CREATION DATE : 06-MAR-12
BID NUMBER: 7449492,1
TITLE: Replacement of (3) Cooling Towers & (2) Condenser Sys , RI College
BID CLOSING DATE AND TIME: 16-MAR-2012 01:45:00

REPLACEMENT OF THREE COOLING TOWERS
& TWO CONDENSER-WATER PIPING SYSTEMS,
GAIGE & WHIPPLE HALLS

ADDENDUM TO PLANS AND SPECIFICATIONS

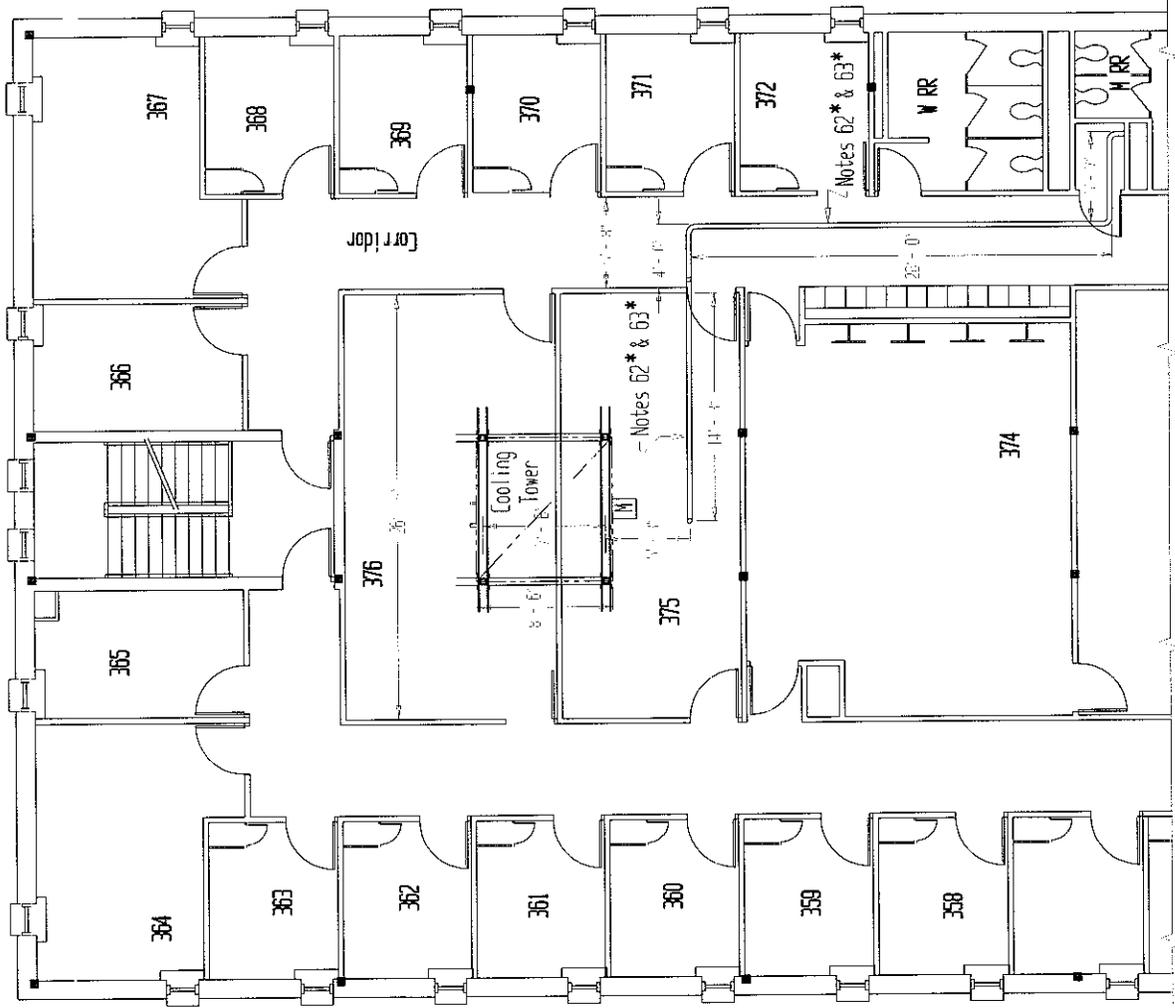
61. To Improve the Clarity of this PLAN, the Rooftop Cooling Tower & Some of Its Supporting Steel Beams are Super-Imposed onto this PLAN of the Third Floor of Gorge Hall's West Wing.

62. At the Location in Room 375 where the 2" D Schedule 80 PVC Drain Pipe Drops Down from Its Roof Penetration to an Elevation above the Suspended Ceiling, this Piping System is to Elbow East to the Horizontal. Convert the Piping to 2" D Schedule 40 PVC. F&I this Drain Pipe 14'-3" East & then through a 2- 1/2" D Core-Drilled Hole in the Drywall that Constitutes the Corridor's West Wall. Elbow the Pipe Down 3" - 6" to Elbow East & Pass under the Ductwork Located above the Corridor's Suspended Ceiling (about 4' - 0") to Elbow South. Continue to F&I this 2" D PVC Drain Pipe South (about 26' - 0") to Elbow East & Pass through a Core-Drilled Hole in the Drywall Located above the Janitor's Closet Door (the Corridor's East Wall). Then Elbow the Drain Pipe Down through a Core-Drilled Hole in the Janitor's Closet Drywall Ceiling to Elbow Horizontal below the Ceiling to the Rooms' Southeast Corner. Then Elbow the Pipe to Drop Vertical (in the Room's Southeast Corner) to TWO 45 Elbows, so that the Pipe Drains into the Janitor's Sink in this Room with No Likelihood of Spilling. F&I NO Cut-Off Valves.

63. F&I the Required Clamps, Threaded Rods & Saddles to Suspend this Drain Pipe from the Existing Steel Joists that Support the Roof Deck (above the Ceilings). F&I also Any Appropriate Wall-Mounted Pipe-Hanger Brackets for the Exposed Horizontal & Vertical Piping in the Janitor's Closet. F&I also 1" Thick Owens Corning Vapor Wick Insulation on the Entire Length of the Drain Piping System, both on the Roof & within the Building (Except the Vertical Drop in the Janitor's Closet). The Insulation on the Roof is to have White PVC Jacketing.

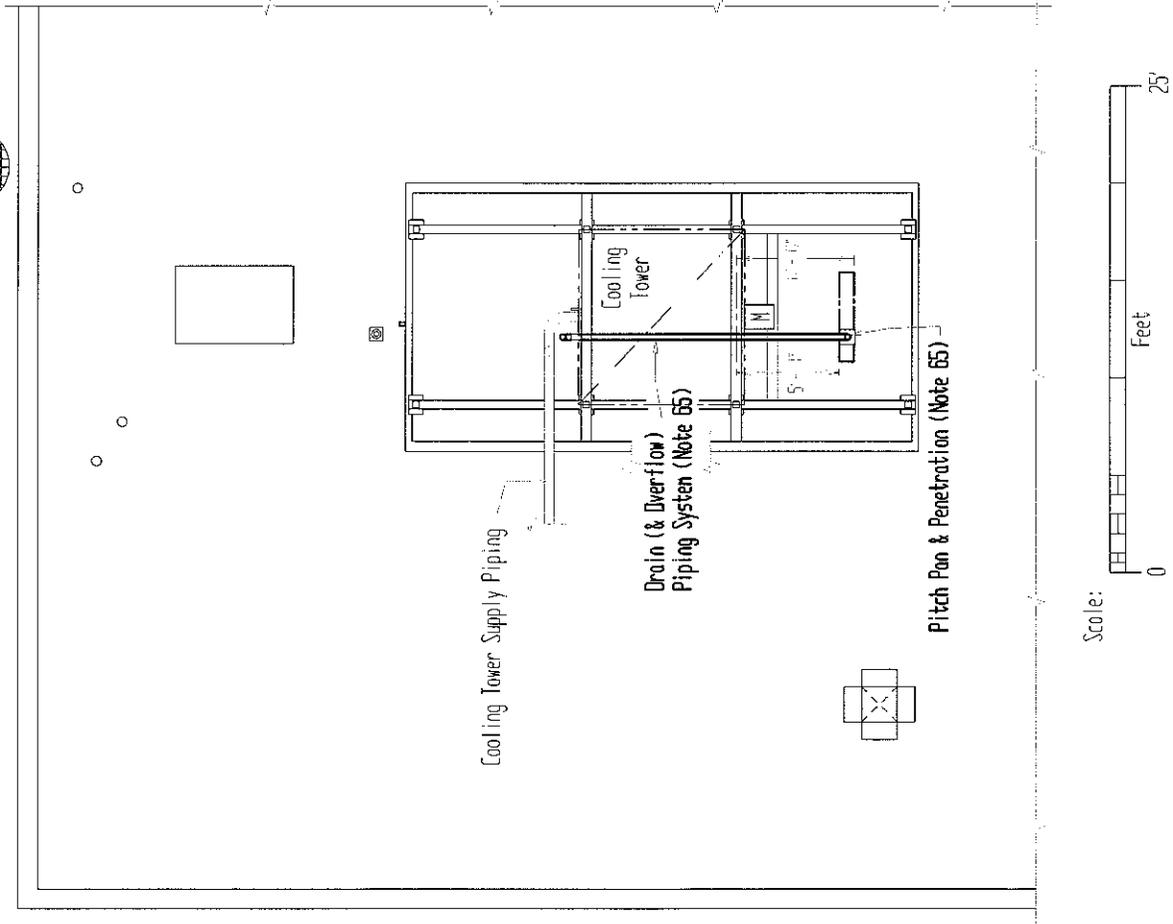
- Notes:
- 64. To improve the Clarity of this PLAN, Only the Information Needed to F&I the Revised Overflow & Drain Piping Systems is Depicted.
 - 65. Instead of Accomplishing the Work on the Overflow & Drain Piping Systems Specified in Note 30: F&I a 3" D Schedule 80 PVC Pipe with ONE 90° Elbow & Connect Same to the Overflow Pipe Connection Located on the Tower's North Elevation. F&I this PVC Pipe to Elbow Down & Descend Vertically Only about 1' - 1" until it is at the Same Elevation as the 2" D Drain Pipe Connection; But Extend the 3" D Piping for enough to the North so that a 2" D Cut-Off Valve can be F&I Between the Tower Drain Connection & the Vertical Overflow Pipe. F&I a Horizontal 2" D Schedule 80 PVC Pipe with the 2" D (Full-Throat) Cut-Off Valve & a 2" x 2" x 3" D TEE & Connect Same to the 2" D Drain Connection Located Directly Below the Overflow Connection; the 3" D Overflow Pipe Terminates in this TEE. From the TEE, F&I the 2" D Schedule 80 PVC Pipe Sufficiently Down to Elbow South & Pass Under the Cooling Tower to Drop Down through a Core-Drilled Hole in the Roofing System & Root Deck & Connect into the Piping System of Notes 62 & 63 on the Previous PLAN. F&I Two or Three Horizontal East-West 1-5/8" x 1-5/8" x 1/4" Thick Primed & PAINTED Unistruts Bolted to the Bottom Flanges of the Two Main North-South Support Beams; Drill the Required Bolt Holes in these Flanges. From the Unistruts & from the Clamps F&I onto the Bottom Flanges of the Existing East-West Beams: F&I the Required 1/2" D Stainless-Steel Threaded-Rods, & Pipe Saddles to Support the ENTIRE 2" D Drain Piping System at a MIN Pitch of 1/4" per Foot. The Roof Penetration is to be F&I at a Location Between 5' - 3" & 6' - 0" South of the Centerline of the Cooling Tower's Southern East-West Support Beam. Use One of the Following Manville-Certified Roofing Contractors to F&I the 20-Dunce Lead-Coated Copper Pitch Pan to WaterProof the Penetration.: Eagle-Cornice or Gorman Roofing. To Protect the Drain (& Overflow) Piping System from the Sun's Ultraviolet Rays, Wrap the Entire System with PVC Heavy-Duty Jacketing.

- 63. CORRECTION: Only that Portion of the Drain (& Overflow) Piping System Located within the Building is to be Insulated with Vapor-Wick Insulation.

- 66. All of the Work Described in this Addendum & Specified by Note 32 are to be Accomplished as Part of the Base Bid.
 - 67. Although Not Mentioned in Notes 62 & 63, F&I Two Dandy Clean-Outs in the 2" D PVC Drain System at Locations to be Designated by the Engineer at the Pre-Construction Meeting.

- 32. To Eliminate any Confusion that Occurred during the Pre-Bid Meeting, Note 32 is Repeated on this PLAN: Note 5 (East Wing) is CORRECTED: The Recently Replaced Variable-Frequency Drive (VFD) for the East Wing's Cooling Tower Fan Motor 1 is Designed for Use with a 30-HP Motor; But the Replacement Cooling Tower Fan's Motor at this Contract is of Smaller Size: 20 HP. Therefore, Contractor is to Remove the Existing 30-HP VFD & Hand Some to the Engineer at the Physical Plant's Stockroom. F&I an AC Tech Model SH-Y Variable-Frequency Drive Rated for a 20-HP Motor at the Same Wall Location as the Existing; Reconnect All Electric Service & Ground Cables. However, Alter the Conduits to Accommodate the Different Physical Size of this 20-HP VFD.
